RELATED CORRESPONDENCE

Re: In the Matter of Commonwealth Edison Company
(Braidwood Station, Units 1 and 2)
Docket Numbers 50-456 and 50-457 *OC*

Reference (a) provided the results of the NRC Construction Appraisal Team (CAT) inspection conducted at Byron Station, Unit 2 on August 19-30, and September 9-20, 1985. During this inspection, certain activities were found in violation of NRC requirements. Attachment A to this letter contains Commonwealth Edison's response to the Notice of Violation appended to reference (b). Attachment B to this letter addresses the three construction program weaknesses identified in the CAT report. On January 8, 1986, Commonwealth Edison was granted a fourteen day extension on the due date for the response to the Notice of Violation.

Figure 38-6

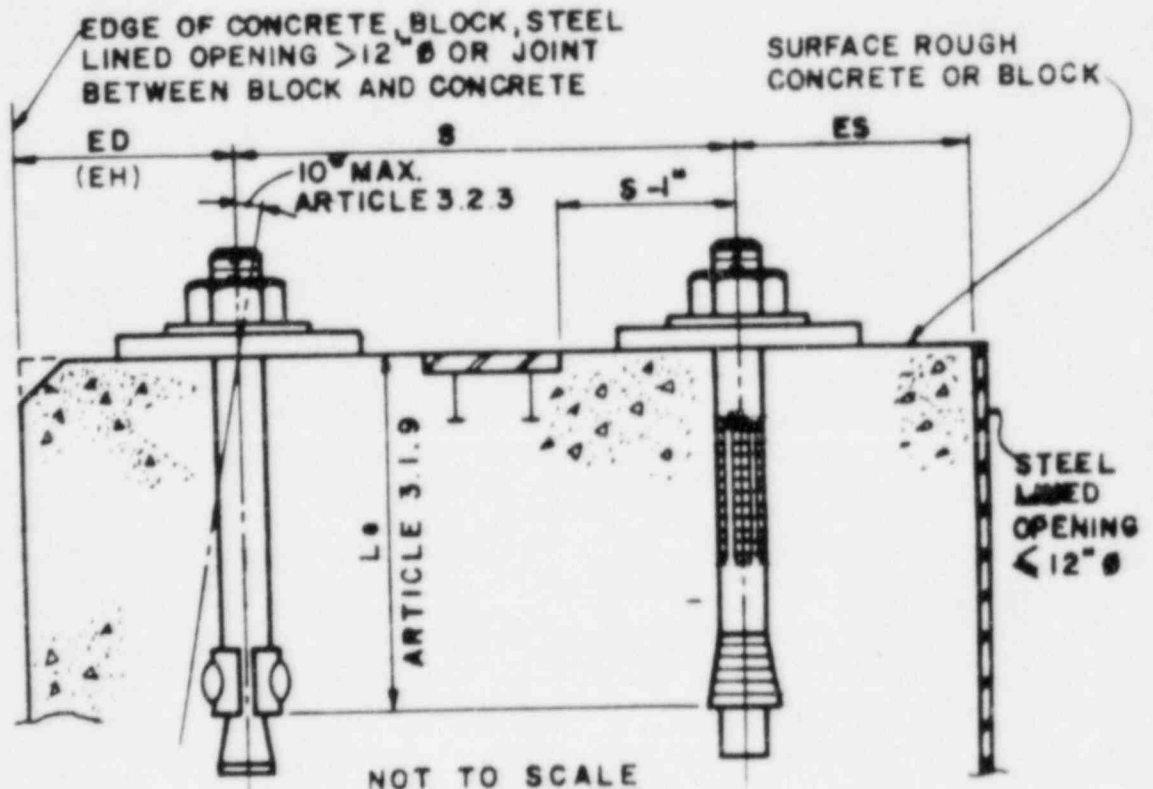
RESPONSE

The Standard Specification for Concrete Expansion Anchor Work, Form BY/BR/CEA, provides the installation and inspection requirements for concrete expansion anchors. Within this document is Figure 38-6, copy attached, which shows the embedded length (L_e) measured from the surface of the concrete to the bottom of the expansion ring. The qualification report for concrete expansion anchors is entitled, "Report on Static, Dynamic and Relaxation Testing of Expansion Anchors in Response to NRC IE Bulletin 79-02", dated July 20, 1981. We extracted two pages from Chapter III of this report, copy attached, which show the embedded length (l_{eb}) measured from the surface of the concrete to the bottom of the expansion ring. This consistently defines the embedded length.

The inspection to verify embedded length is a measurement of the projection of the anchor beyond the concrete in the installed position. Subtracting this measurement from the total anchor length establishes the embedded length. The installed position is defined as being after the anchor has been set by applying an installation torque. As the torque is applied, the anchor slips slightly, pushing the expansion ring outward to produce the wedging force between the ring and concrete. During this setting action, it is assumed that the ring remains stationary as the back of the anchor approaches the expansion ring. The inspection for the embedded length is therefore, consistent with the qualification report.
